PPPO-02-10020228-22

**TRANSMITTAL OF THE REVISED 2016 UPDATE OF THE PADUCAH GASEOUS
DIFFUSION PLANT SITEWIDE GROUNDWATER FLOW MODEL,
DOE/LX/07-2415&D2/A1**

**2016 Update
of the Paducah Gaseous Diffusion Plant
Sitewide Groundwater Flow Model**

Date Issued—June 2022

3.2

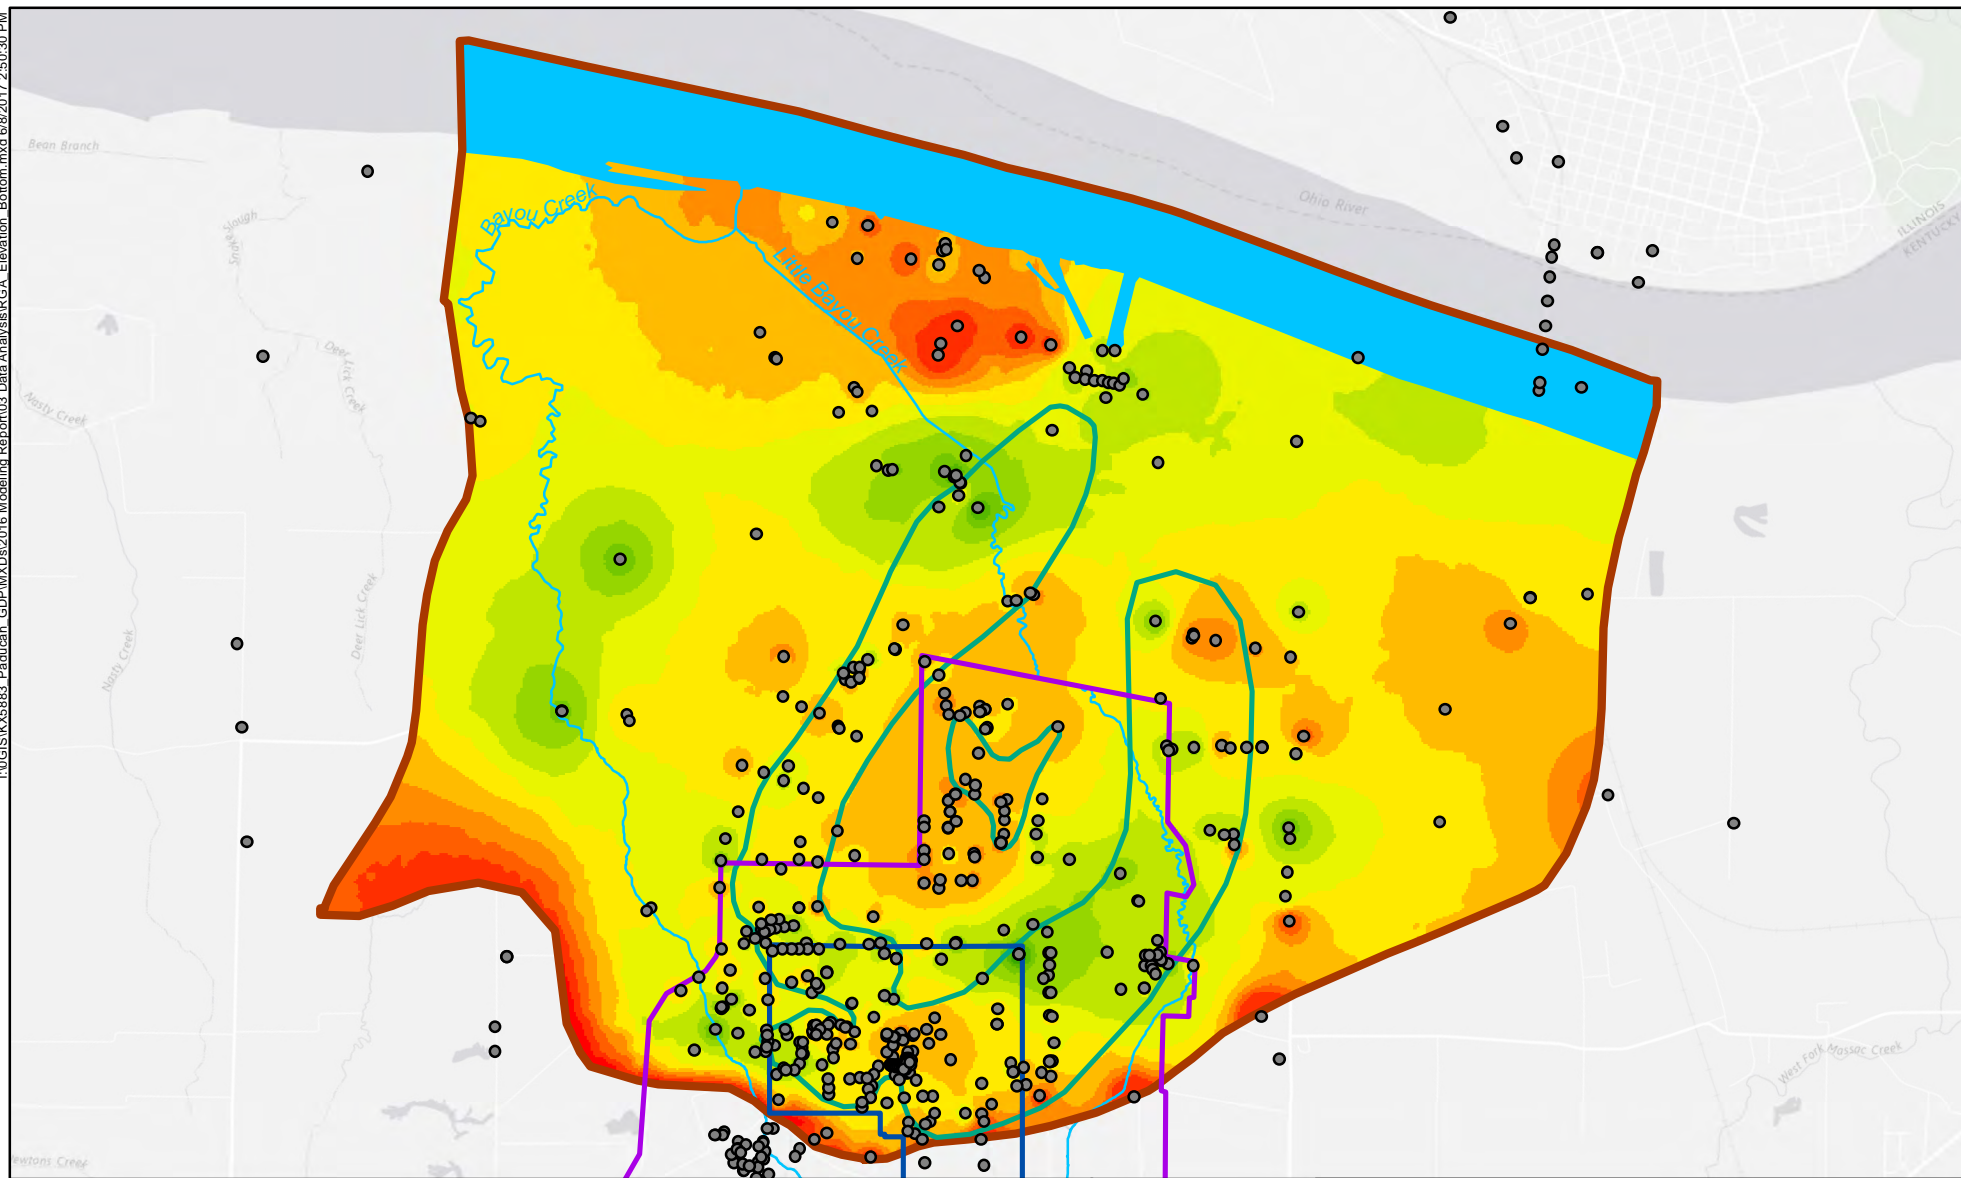
④ Figure 3.2 (conforming Δ)
model boundary reflects 2016
model boundary

3.3

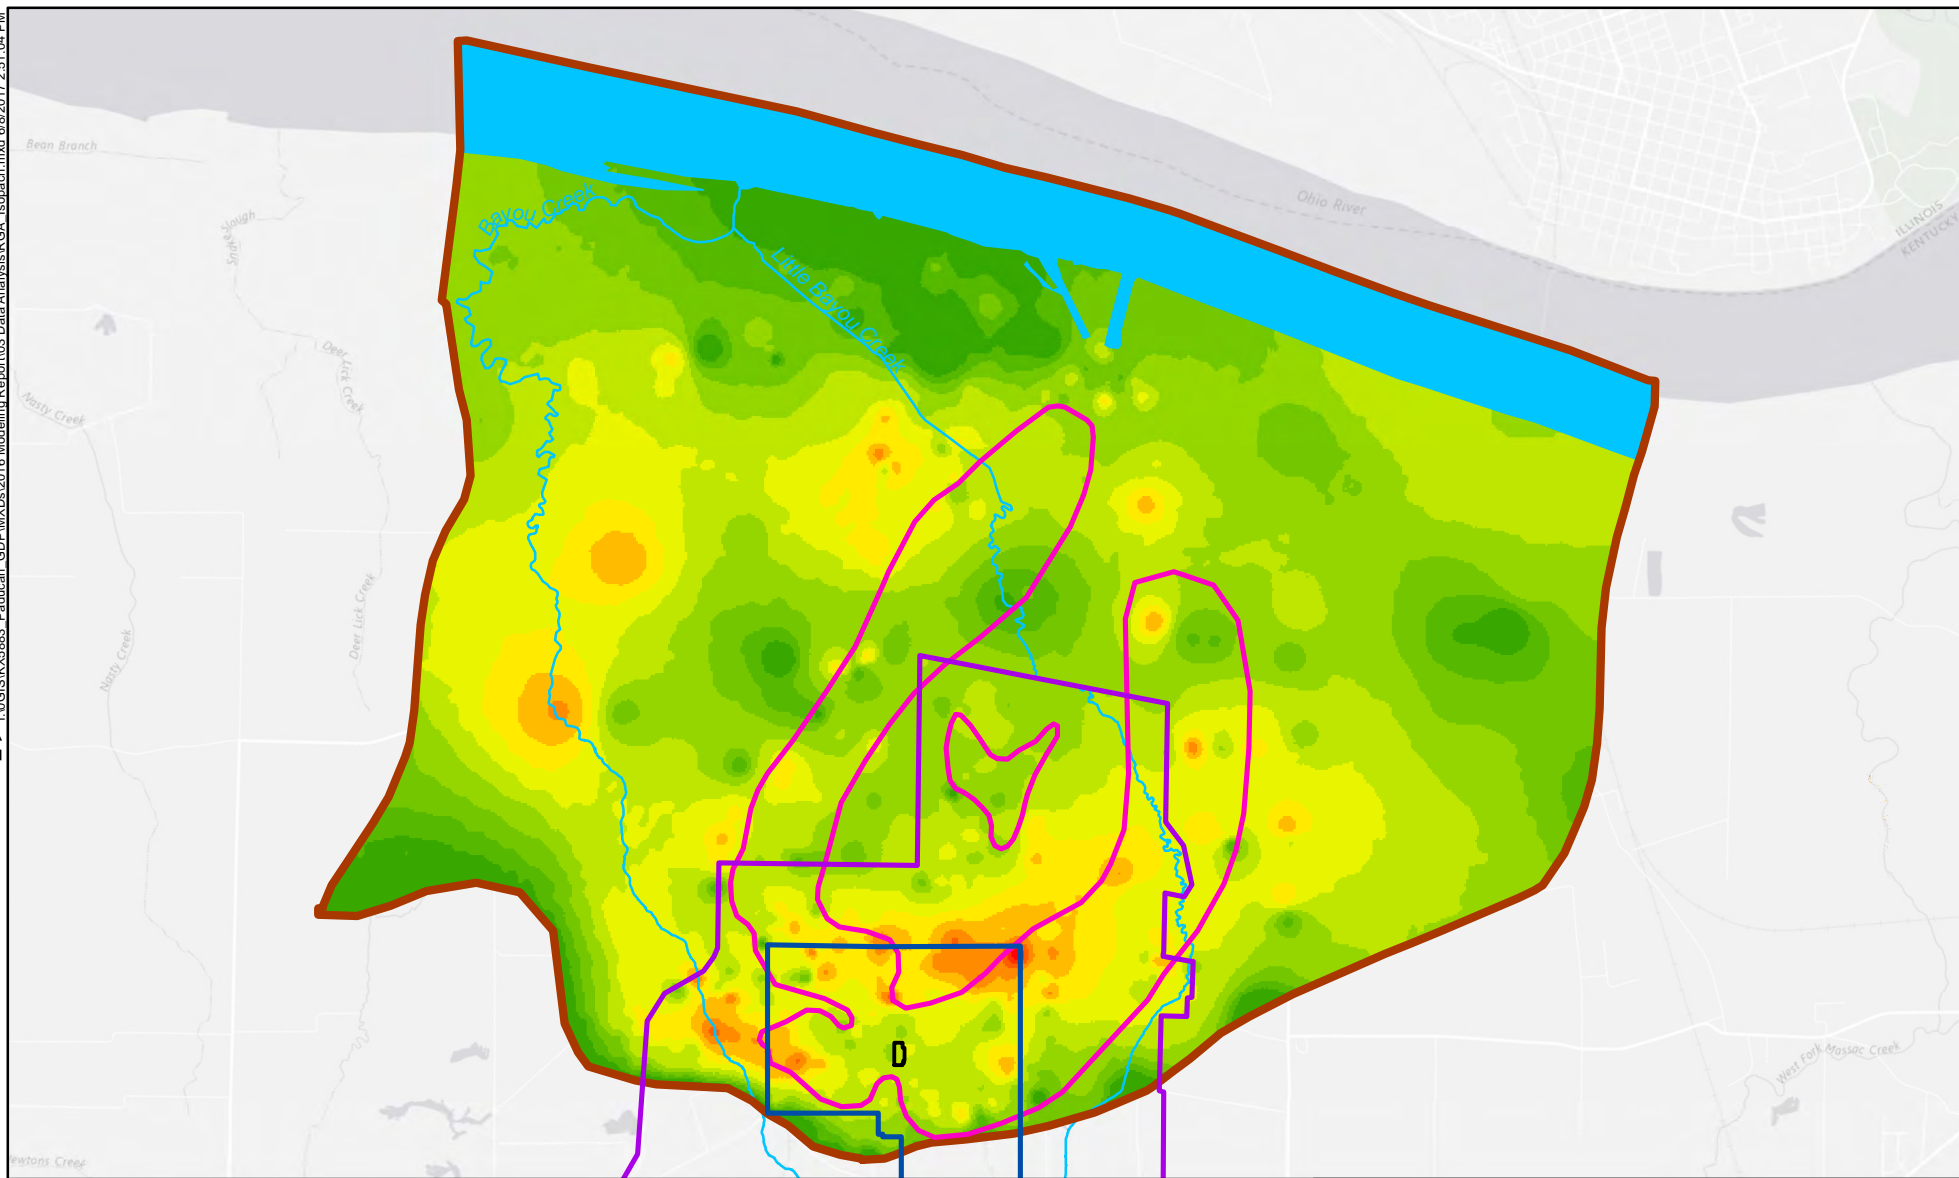
- (5) Figure 3.3 in comparison to 3.2.
- missing bore holes? Resolved.

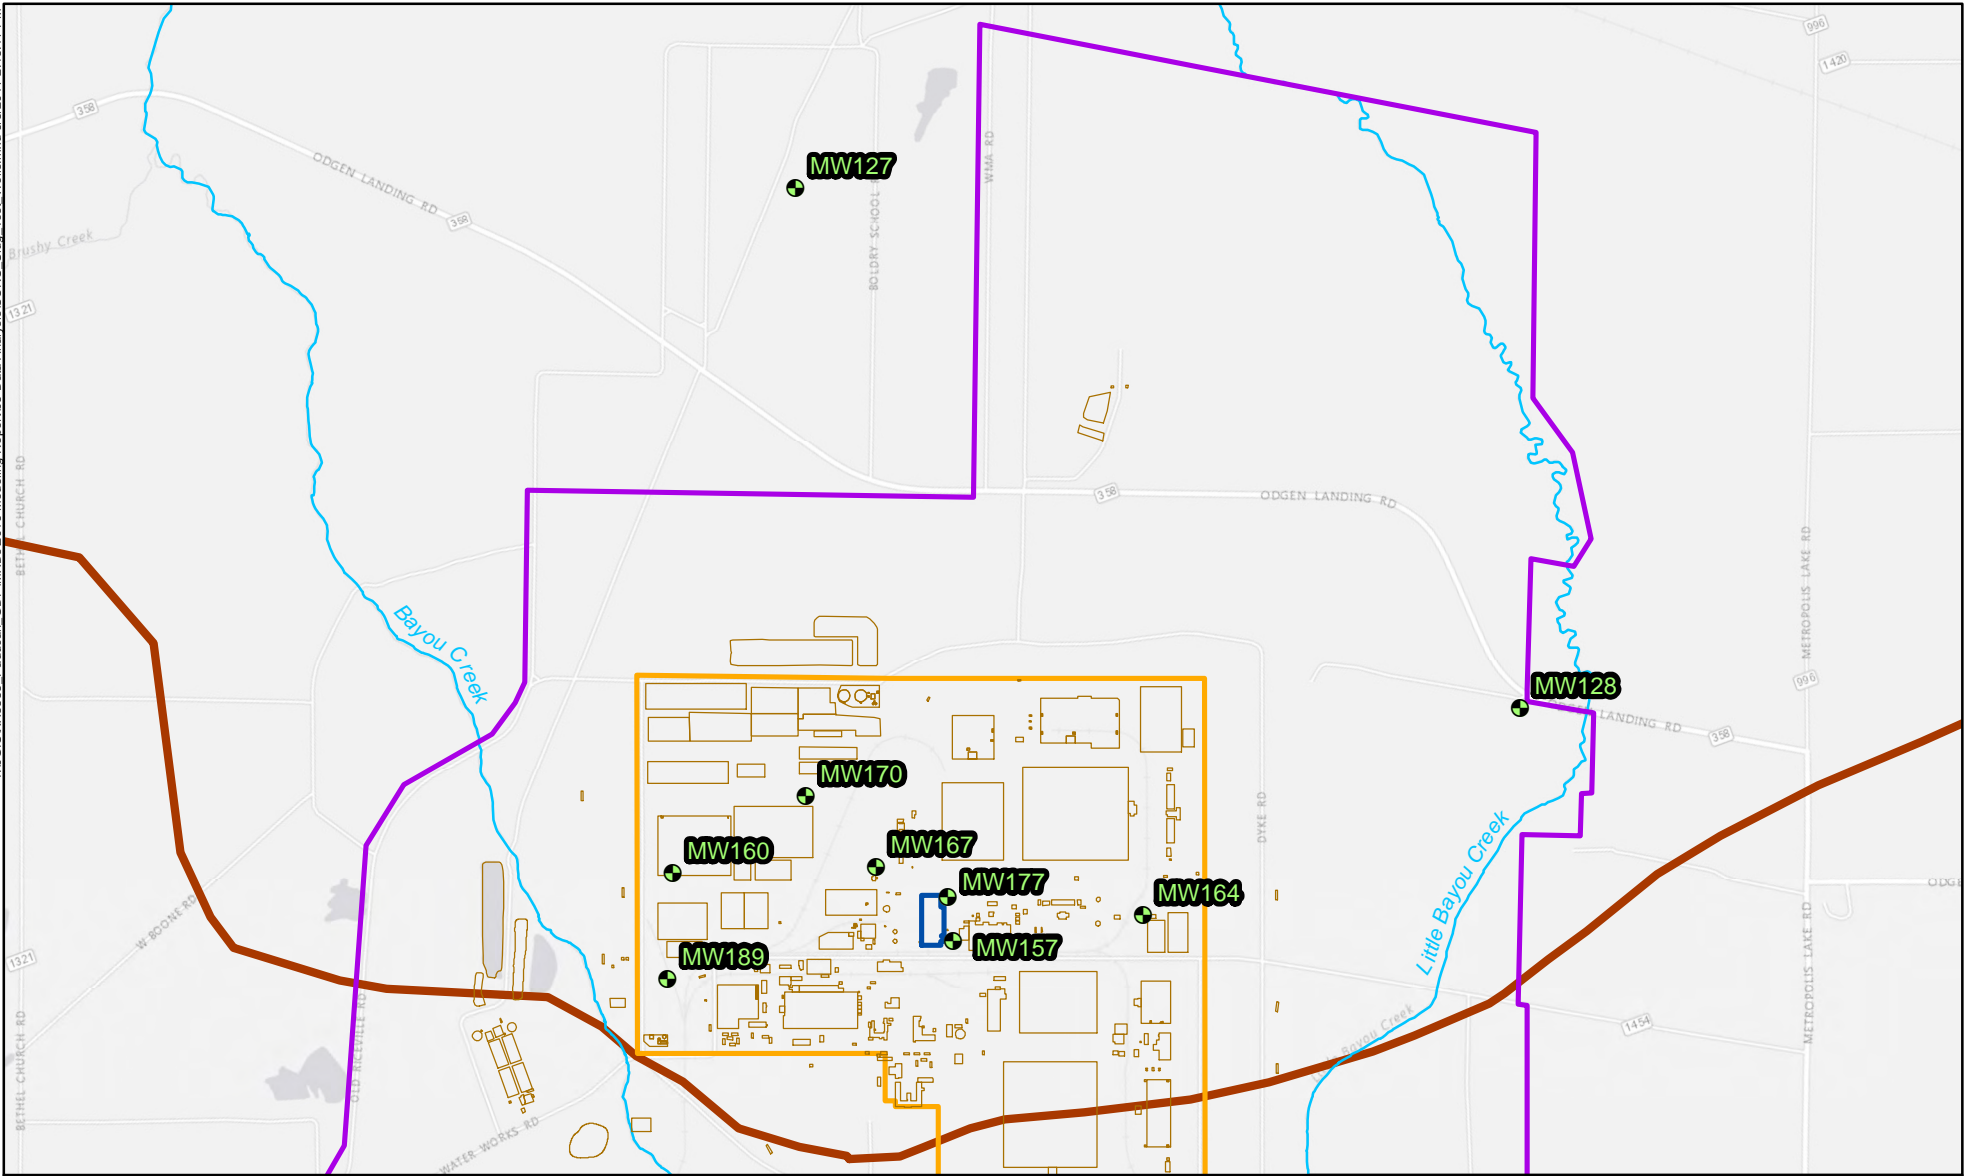
Figure 3.7—both TVA supply lines should be bolded instead of just one; consider using a different color or no color for the plume boundary; figure needs to be revised to indicate that buildings are highlighted to show areas of increased recharge due to water retained in the gravel; figure needs to be revised to highlight fire water piping and associate the 40 gpm leak with the piping (not the buildings).

20) Figure 3.7 (label H_2O line)

23) Figure 3.7 (plume map ϕ blue)

25) Figure 3.7. (delineate Fire H_2O ~~teak~~ line)

27) 40 gpm leak - more detail &
^{50 gpm}
discussion (inc. any building
w/ nuc material & C-310 & C-315
& cooling towers) \Rightarrow highlight on Fig 3.7
& add to text

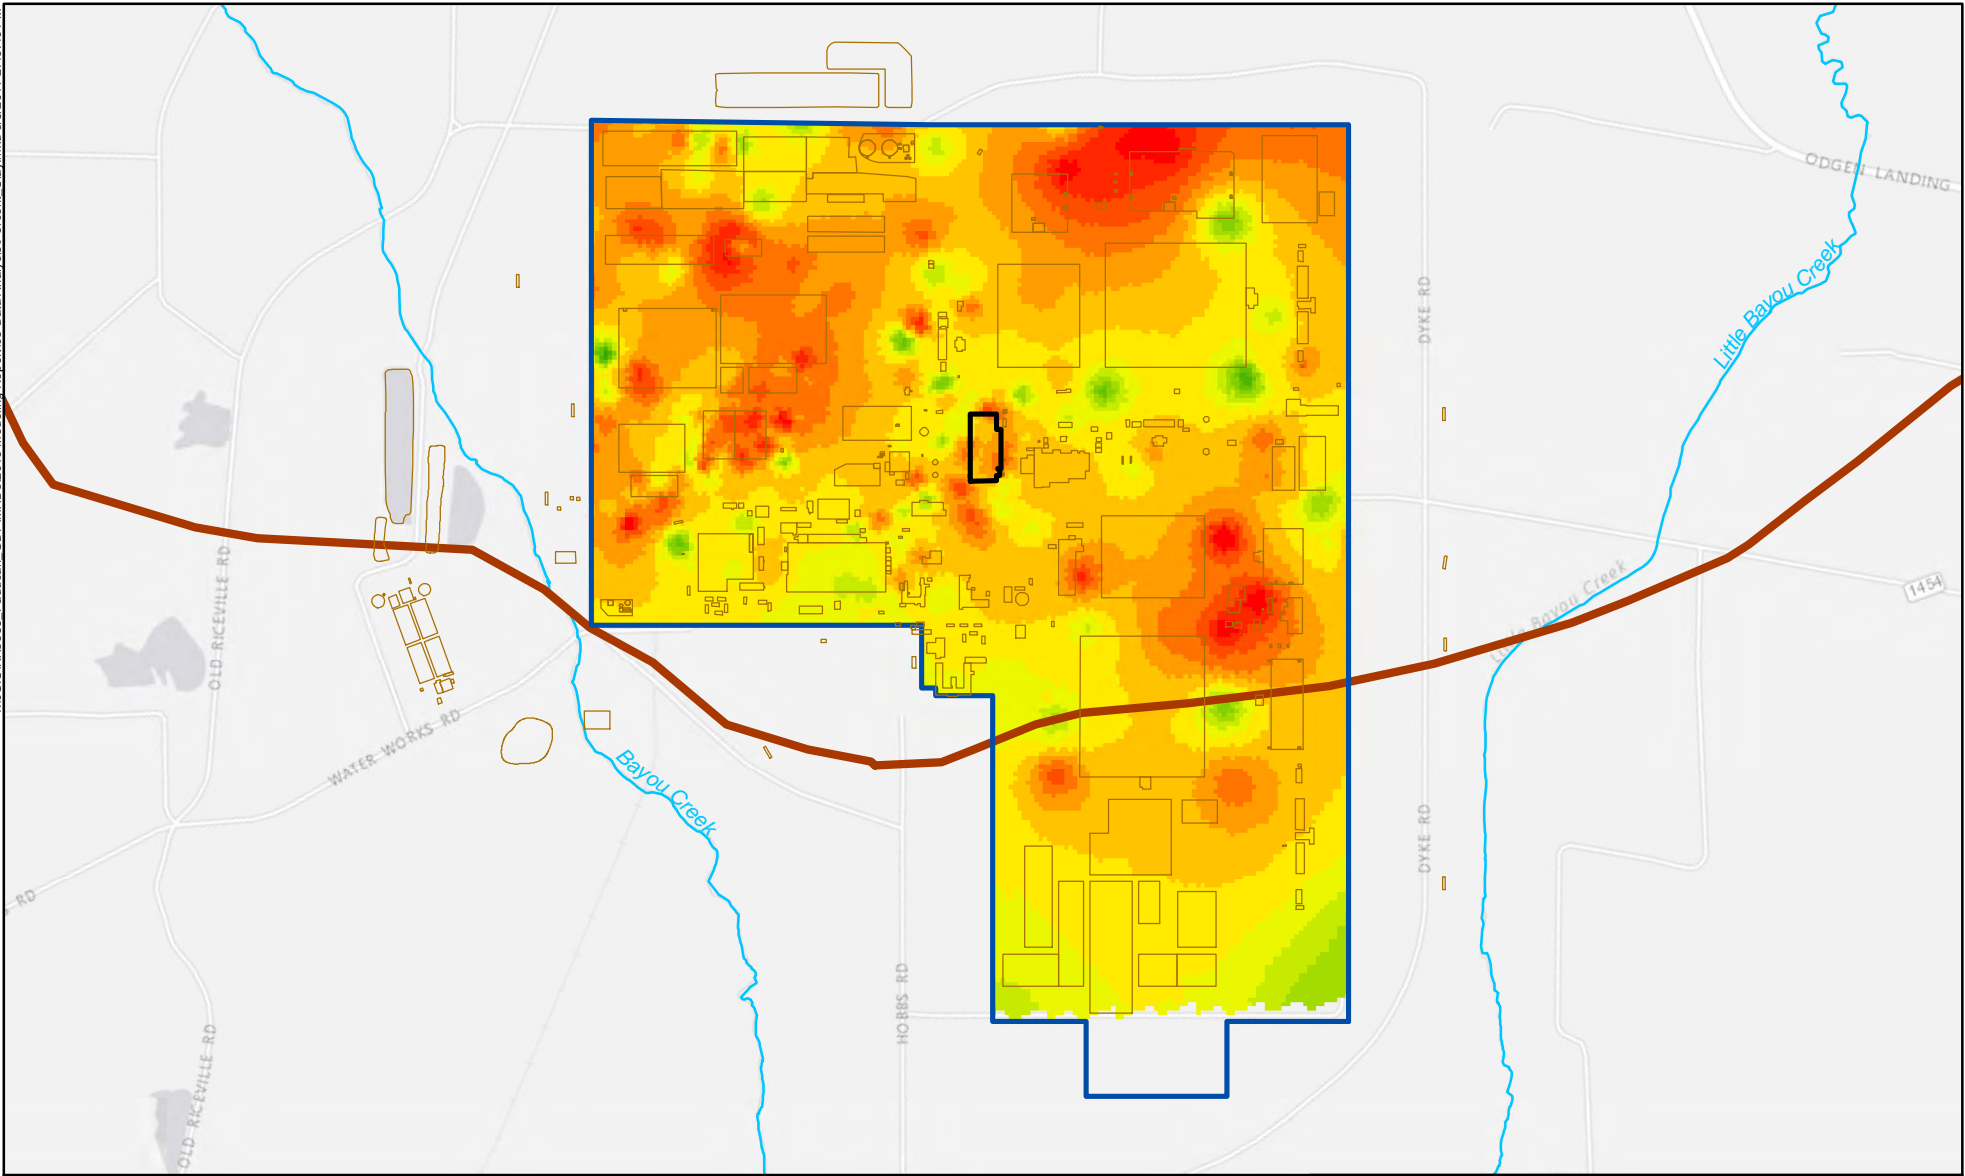
3. Pg-10: Based on the minimum clay/silt of 30-35% in the entire model domain, the maximum recharge allowed within the site is 29 in/yr. Figure 3.8 (text has wrong reference to Figure 3.7) shows only a few green dots representing clay/sit between 40-50% range. That means the maximum recharge should not be more than 22 in/yr. In fact, 22 in/yr is the number the MWG agreed to use. Figure 3.8 does not justify using any higher maximum recharge rate.
